Contract #: 04-0120F4Cty: SF/ALA Rte: 80 PM: 13.2/13.9File #: 69.25B**QUALITY ASSURANCE -- NON-CONFORMANCE REPORT****Location:** Changxing Island, Shanghai, P.R. China**Report No:** NCR-000392**Prime Contractor:** American Bridge/Fluor Enterprises, a JV**Date:** 17-Aug-2009**Submitting Contractor:** Zhenhua Port Machinery Company, Ltd (ZPMC), Changxing Island**NCR #:** ZPMC-0366**Type of problem:****Welding****Concrete****Other****Welding****Curing****Procedural****Bridge No:** 34-0006**Joint fit-up****Coating****Other****Component:** OBG Segment 6AE Side Panel Repair**Procedural****Procedural****Description:****Reference Description:** Unacceptable Base metal repair on OBG side panel**Description of Non-Conformance:**

Job Name: SAS Superstructure

Subject: NCR No. ZPMC-0366

Reference Description: Unacceptable Base metal repair on OBG side panel

Component: Crossbeam CB17

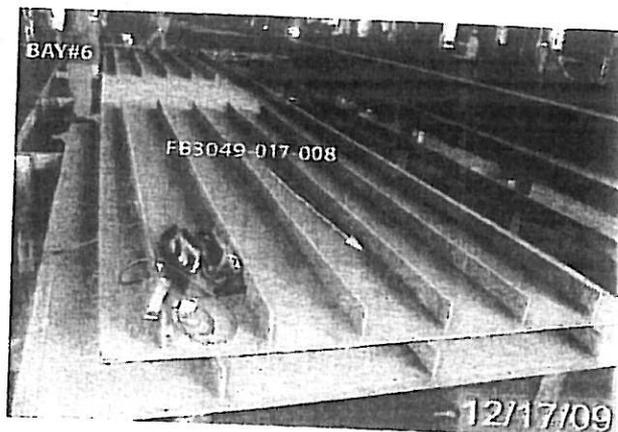
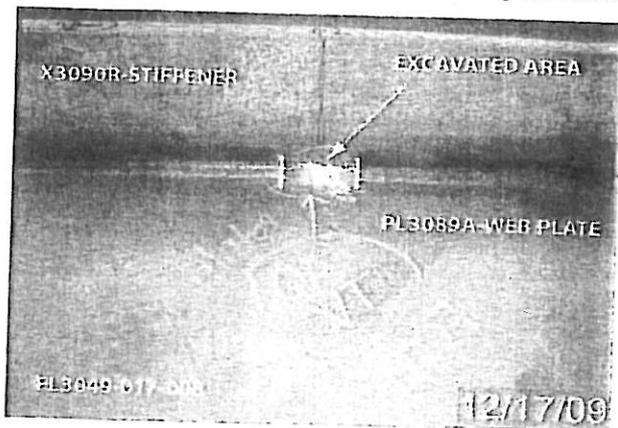
During a random in-process visual verification prior to performing Magnetic Particle Testing (MT) on a Floor Beam (FB) for Crossbeam CB17 located at Bay # 6, the Caltrans Quality Assurance (QA) Inspector observed a fillet weld that had been excavated approximately 50 mm in length and 6 mm in depth. The contractor (ZPMC) offered a formal NDT Inspection Notification Sheet, acknowledging the weld was complete and that ZPMC MT technicians had tested and accepted 100% MT on this FB. Additional information identifying the non-conformance is listed below.

- The Floor Beam is identified as FB3049-017-008.
- The fillet weld connects the FB Web Plate (PL3089A) to FB Stiffener (X3090R).
- The fillet weld size is 6 mm in size per the approved contract drawings.
- The NDT Inspection Notification Sheet request number was identified as: 004835

Submit a repair procedure to the engineer for approval. A response for the resolution of this issue is expected within 7 days.

Component: OBG Segment 6AE Side Panel Repair

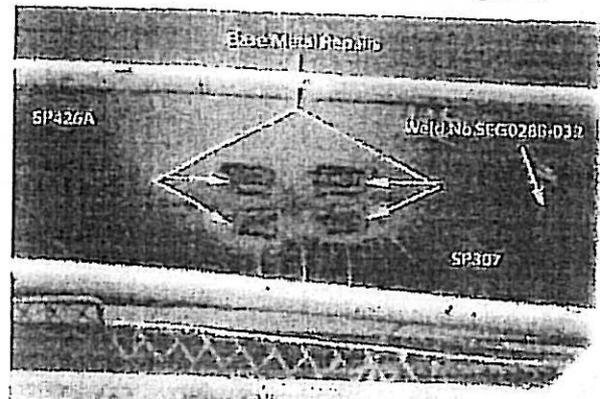
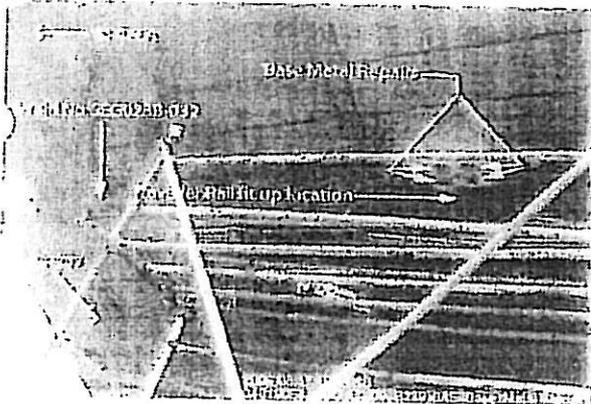
This Quality Assurance (QA) Inspector observed the in-process welding of a base metal repair being performed on side plate SP307 and SP426A adjacent to side plate splice weld No. SEG028B-032 on OBG Segment 6AE. Approximately four areas of 75mm x 75mm of filler material were deposited into four locations, in and around the splice weld to rectify the fit up of the traveler rail bolt attachments by building up the surface thickness to compensate the gap at the faying surface. These additional welds are not in the approved shop drawings or weld map. This is an unacceptable base metal repair and was performed without the approval of the Engineer.

Perform Magnetic Particle Testing (MT) to verify weld quality.

Contractor submitted MT report verifying the quality of the welds.

Welding Repair Report

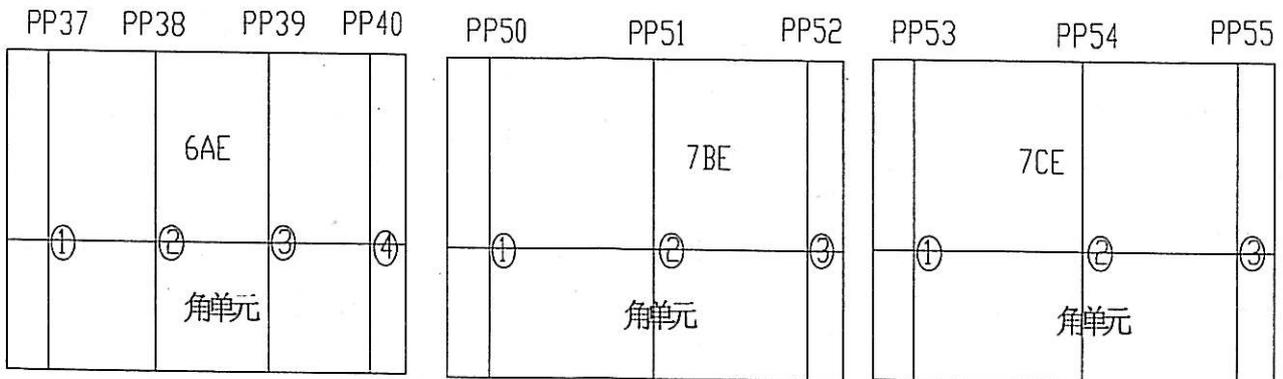
根据检查报告1075#的工艺处理结果,对梁段6AE/7BE/7CE的相关位置进行堆焊处理,并保证工艺要求的平整度。具体见下图!

According to inspection report 1075# disposition, it shall build up 6AE/7BE/7CE relevant position to ensure flatness, see the following draft.

Weld distortion and fabricate error.

1. 按照焊接返修工艺规程 (WPS) 打磨缺陷区域;
 2. 对该区域作100%MT检查, 确保缺陷全部去除;
 3. 根据批准的焊接返修工艺规程 (WPS) 进行预热及焊接;
 4. 将焊接区域打磨至与母材平齐;
 5. 对修补区域进行VT与MT检测;
-
1. Remove all the defects according to the approved repair WPS by means of grinding.
 2. Verify with MT and VT no defects remain in the repair area prior to weld;
 3. Preheat and weld according to the relevant WPS.
 4. Grind the weld flush with base metal after welding.
 5. Perform VT and MT inspection of the repaired area.
